Access Compliance Report Public Rights-of-Way (Curb Ramps)

Intersection ID: 10021328 Main Street: BLAKENEY_HEATH_RD Cross Street: N/A Location: SE

ADA ID: DF16E54EF0D1 Ramp Type: PerpDiag Initial Pass/Fail: Fail Overall Compliance: No Severity Score: 22.5

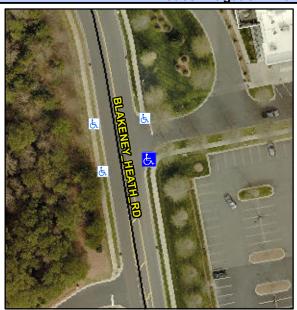
R304.5.1, R304.2.2, R304.5.3

Field Measurements/Component Compilance					
Compliance Description		Data	Compliance Description		Data
N/A	Ramp Length (in)	48.0	No	Ramp Slope (%)	8.4
No	Ramp Width (in)	47.0	No	Ramp XSlope (%)	3.4
N/A	Flare Type LT	N/A	N/A	Flare Type RT	N/A
N/A	Flare Slope LT (%)	N/A	N/A	Flare Slope RT (%)	N/A
N/A	Flare Traversable LT?	N/A	N/A	Flare Traversable RT?	N/A
N/A	Landing Length (in)	N/A	N/A	DWS Provided?	N/A
N/A	Landing Width (in)	N/A	N/A	DWS Contrast?	N/A
N/A	Landing Slope (%)	N/A	N/A	DWS Length (in)	N/A
N/A	Landing X Slope (%)	N/A	N/A	DWS Full Width?	N/A
N/A	Landing Curb? (Y/N)	N/A	N/A	DWS Offset (in)	N/A
N/A	Shared Landing?	N/A			
N/A	Gutter Ponding?	N/A	N/A	Gutter Slope (%)	N/A
N/A	Gutter Lip Ht (in)	N/A	N/A	Gutter X Slope (%)	N/A
N/A	Painted X Walk1?	No	N/A	Painted X Walk2?	No
	X Walk 1 Direction	To N		X Walk 2 Direction	To W
N/A	X Walk 1 Width (in)	N/A	N/A	X Walk 2 Width (in)	N/A
	X Walk 1 Slope (%)	4.1		X Walk 2 Slope (%)	9.5

Remove & Replace Curb Ramp With
Two New Directional Ramps or
Equivalent.
